ADDENDUM No. Two (2)

IFB No. 2019-183

CONSTRUCTION, REROOF COLLIN COUNTY 920 E. PARK BLVD., PLANO

ADDENDUM NUMBER 1

Sheet No. **R1.1**
of 2 Sheets

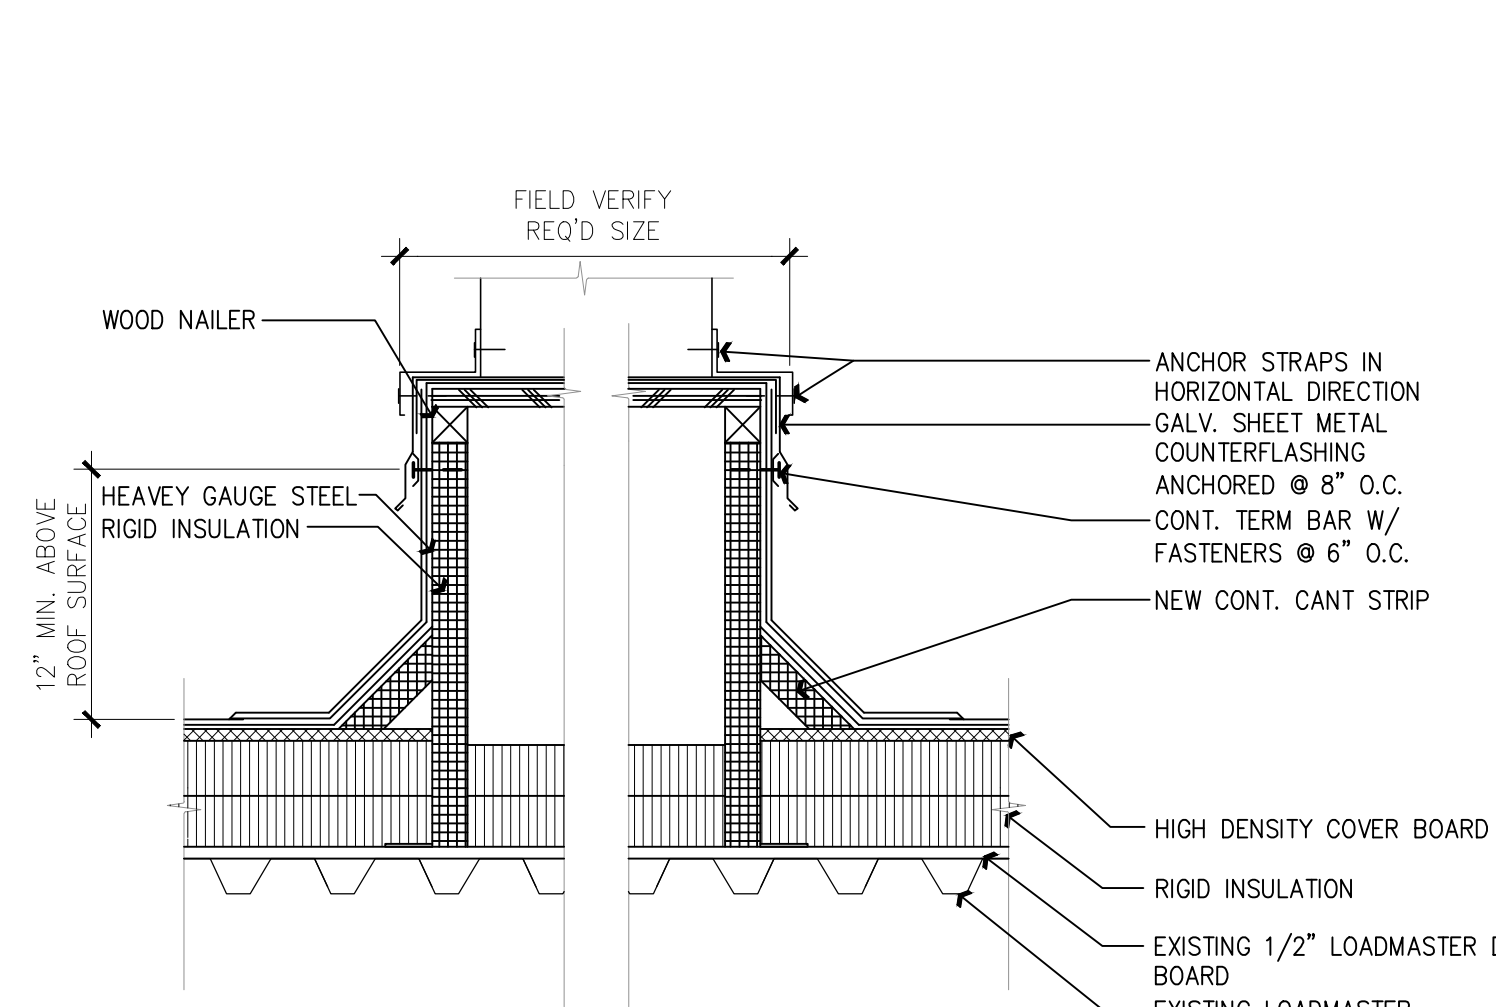
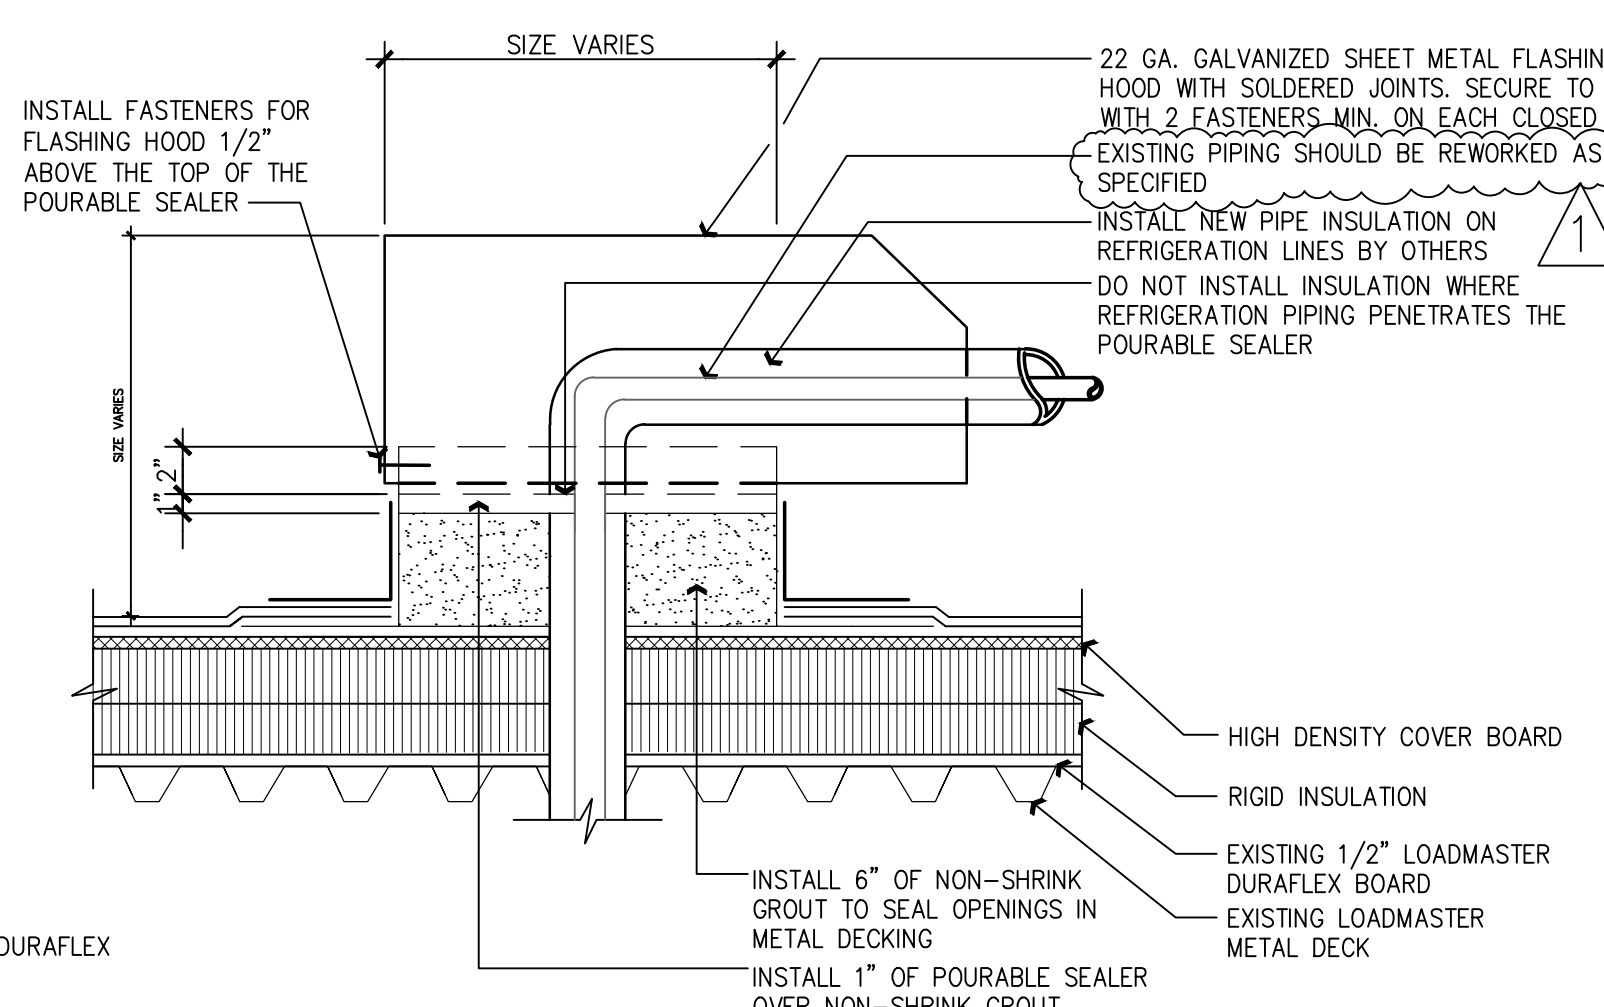
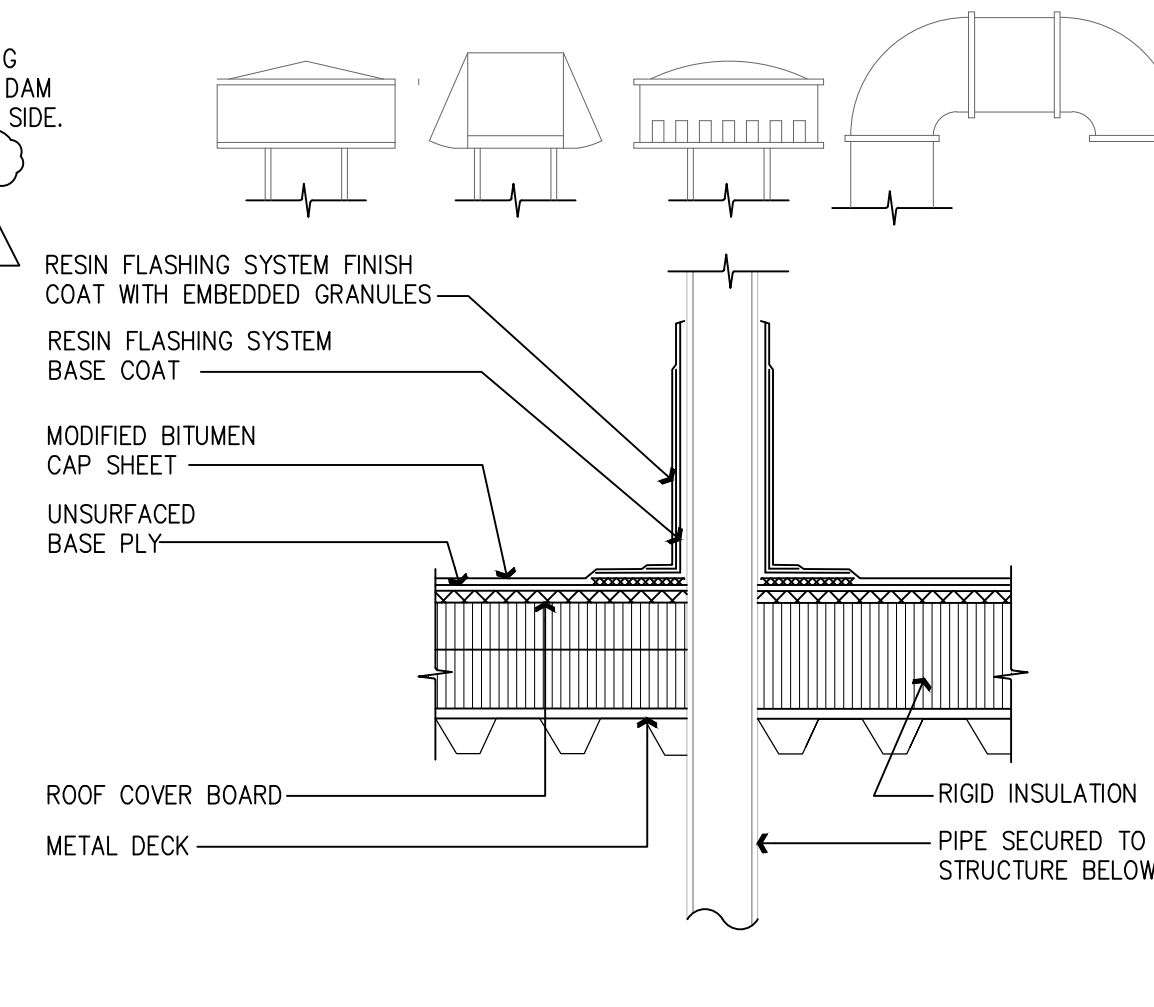
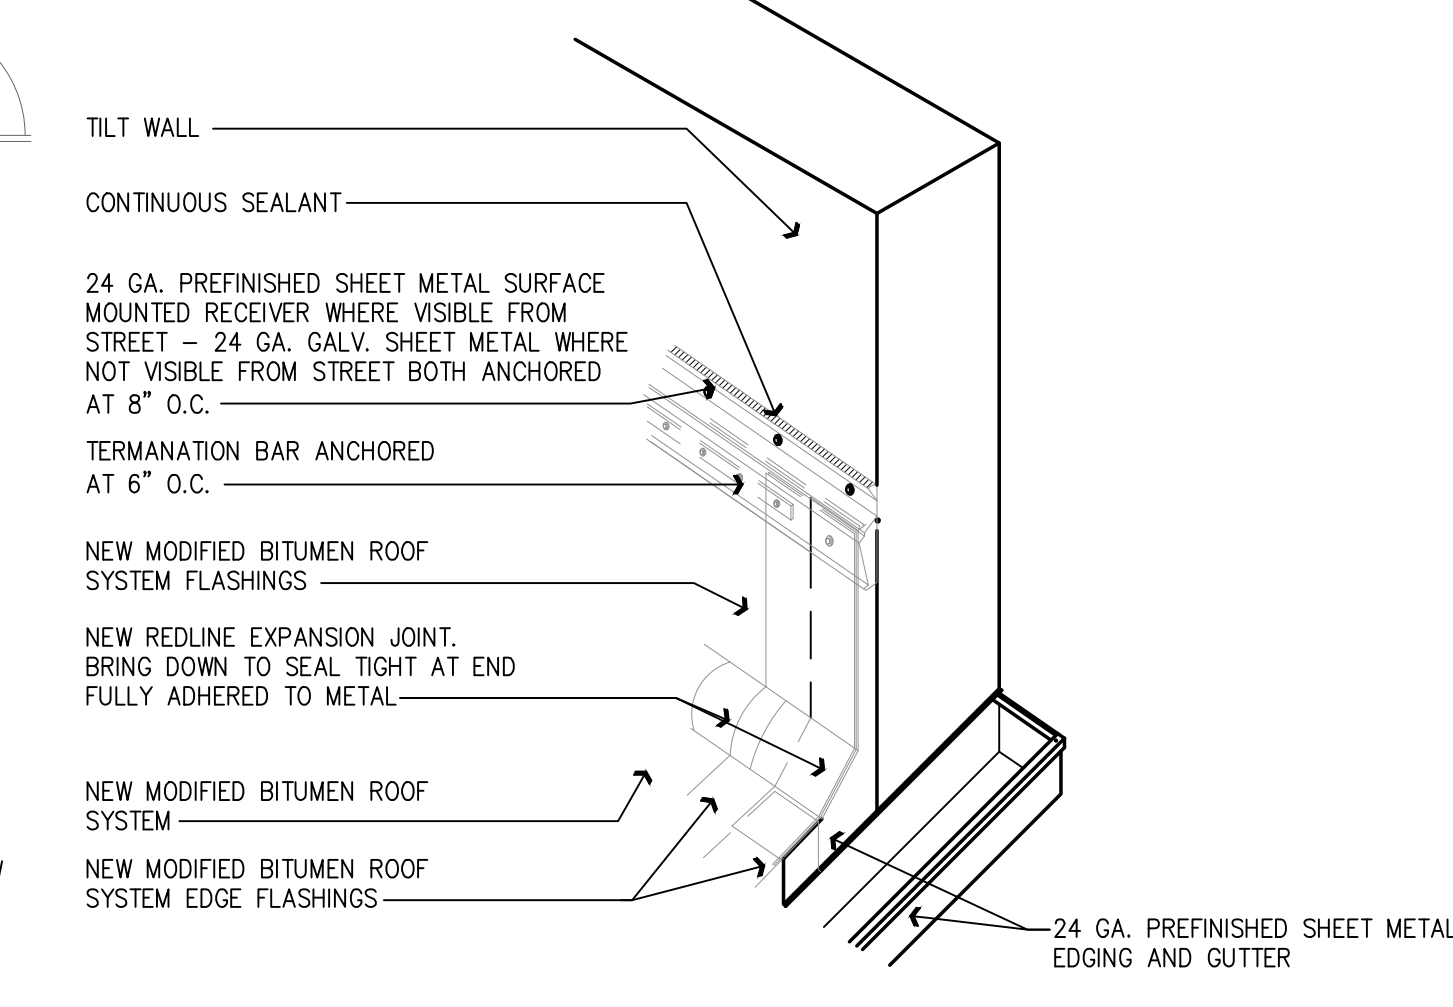
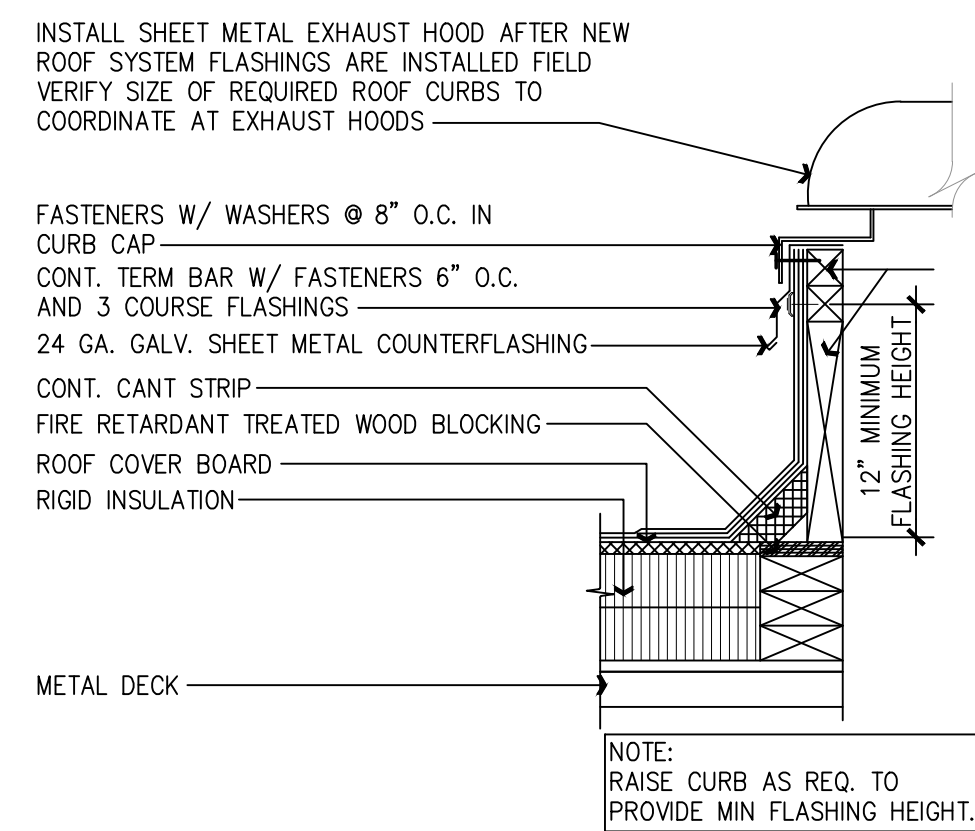
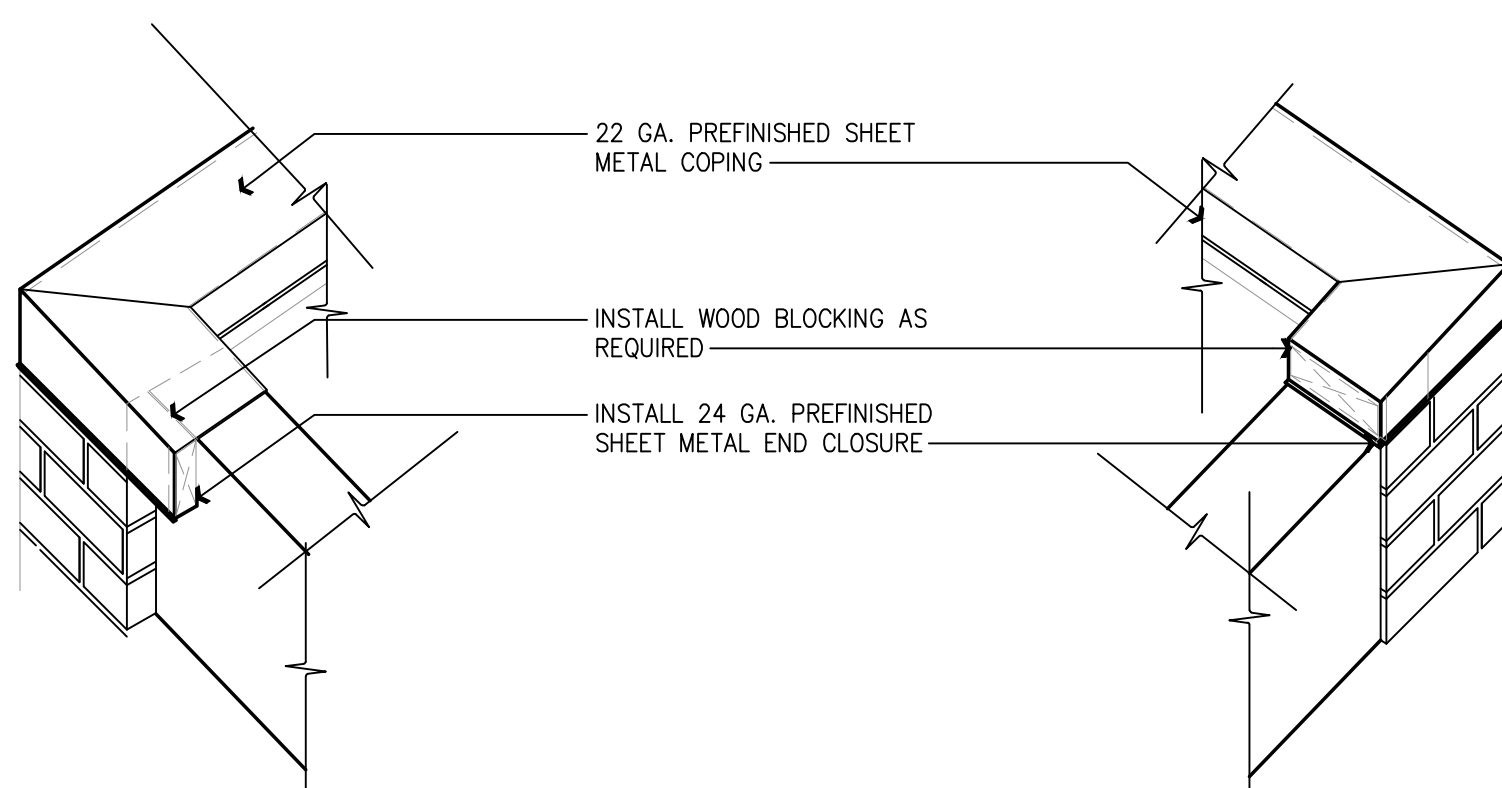
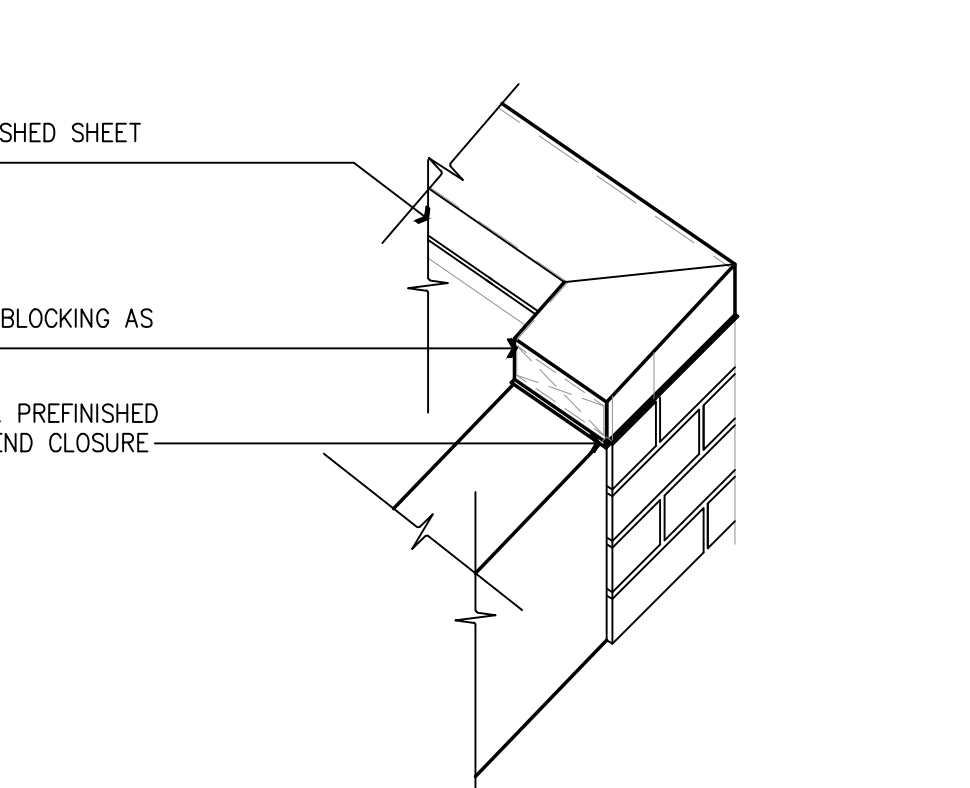
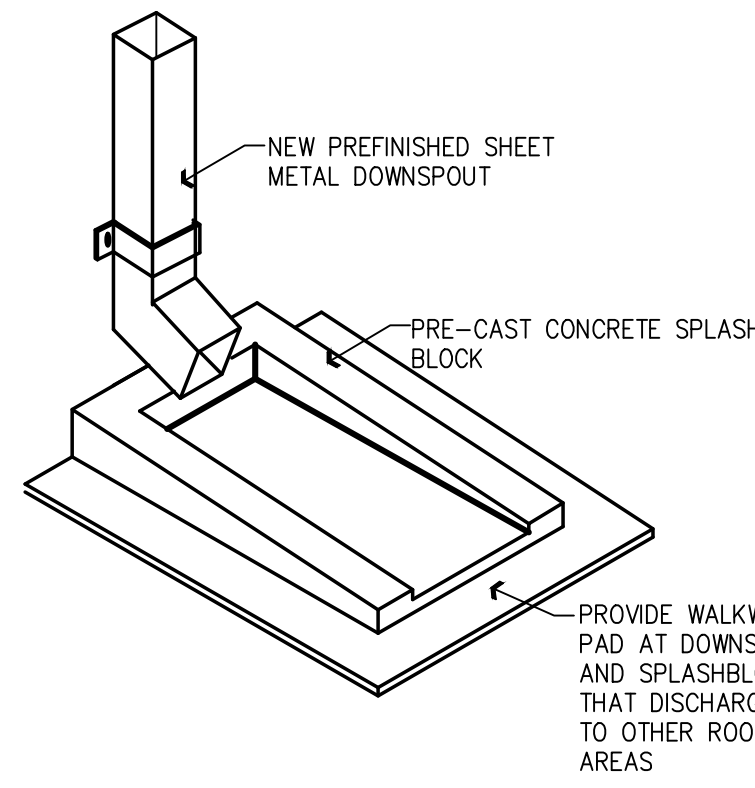
1. The attached revised Sheets R1.0, R1.1 and R2.1 replace the original Sheets R1.0, R1.1 and R2.1 with the changes associated with the Addendum being noted and clouded.
2. The attached Sheet R2.2 is added to the Contract Documents and includes information related to where a dumpster can be positioned, where roofing materials can be staged and where the sky track can be parked.
